This gallery shows some pictures of bad solderings - they should prevent you from making the same errors (feel free to add even more pictures here!)

From:  
<https://midibox.org/dokuwiki/> - **MIDIbox**

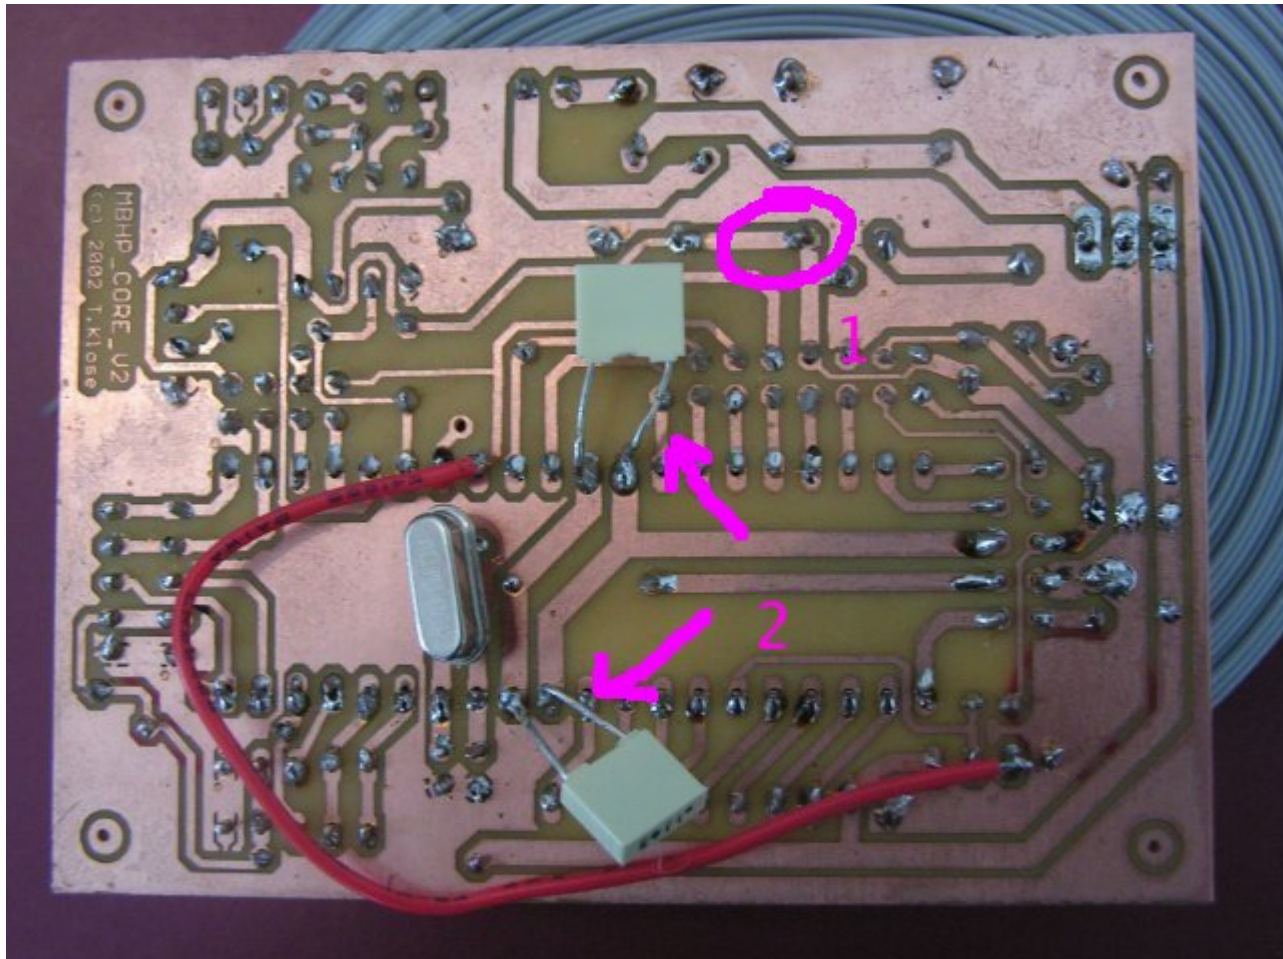
1: The core module has some badly soldered connections(loose), which could lead to failures. There are also missing solderings (e.g. 33pF cap below crystal). It makes sense to solder each pad again, the [Soldering](#) guide in the Wiki gives some useful tips

2: The legs of the caps should be cut, otherwise they can cause a short circuit which can damage the PIC!

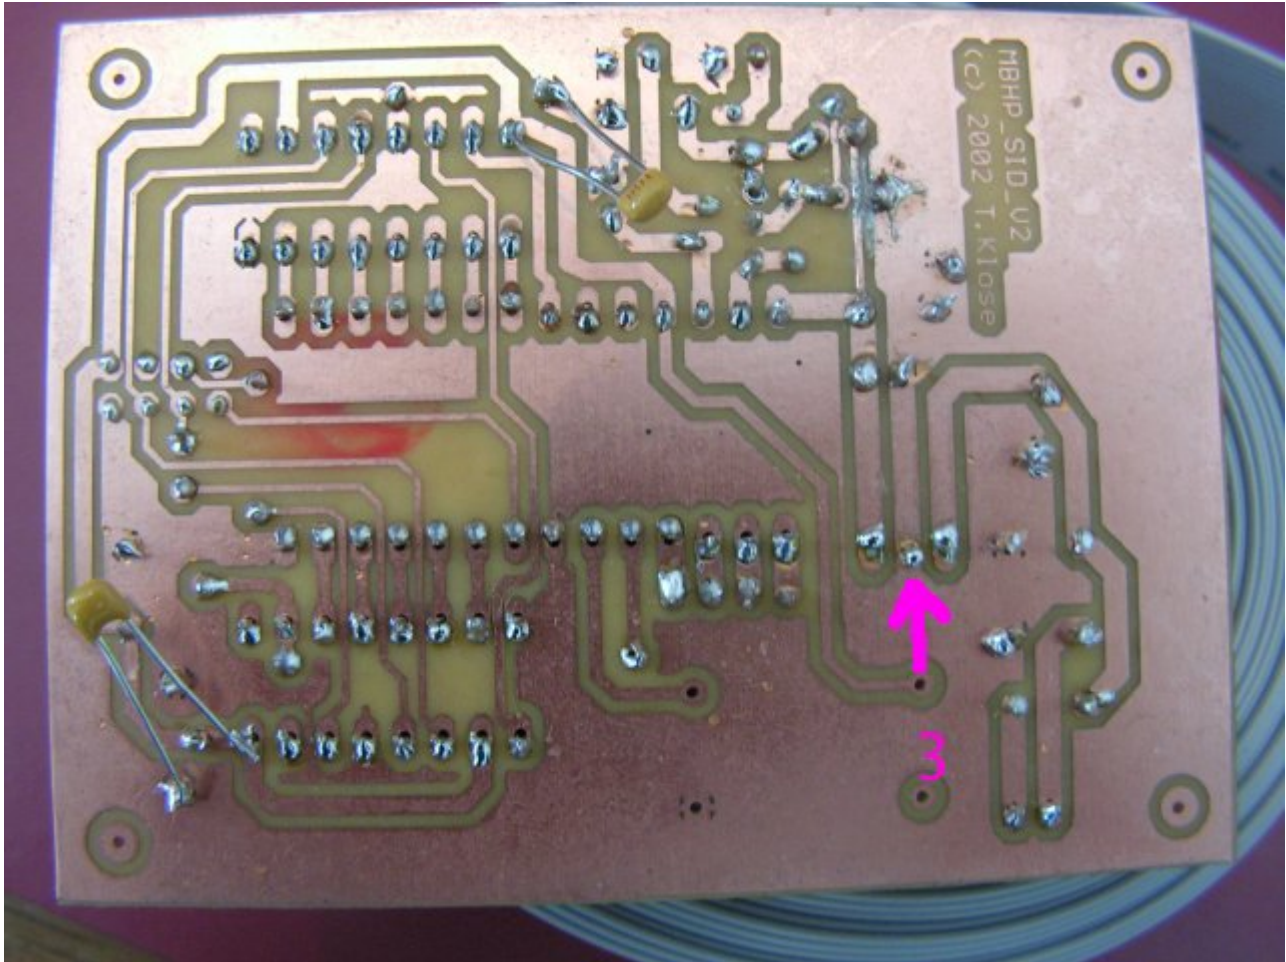
3: This seems to be a bad ground connection directly at the 78xx - it can lead to the wrong voltage. Here the same: just solder the pads again, it will help  
And same as above: the long cap legs need to be cut, the danger of shorting out is too high!
